Date: July 1, 2013

To: Bussmann Customers

Subject: LPN-RK and LPS-RK Class RK1 Fuse Product Change Notice

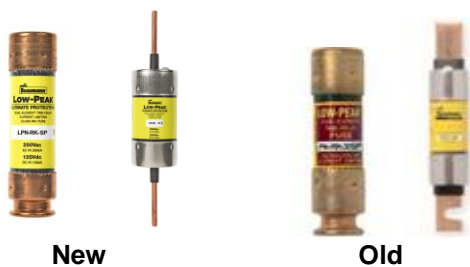
In an effort to simplify fuse selection within our UL low voltage fuse portfolio, Bussmann has introduced the Fuses Made Simple™ program. This new program groups the UL low voltage fuse portfolio into four distinct families, based on key performance characteristics, making it easy for users to select the appropriate fuse. As a part of the Fuses Made Simple™ program, LPN-RK and LPS-RK Class RK1 fuses will feature updated, easy to read Low-Peak fuse family labels.

This label change does not affect the form, fit, function or electrical properties of the fuses.

Below are examples of the old and new style labels. The new labels are yellow in color and have easy to read label information.
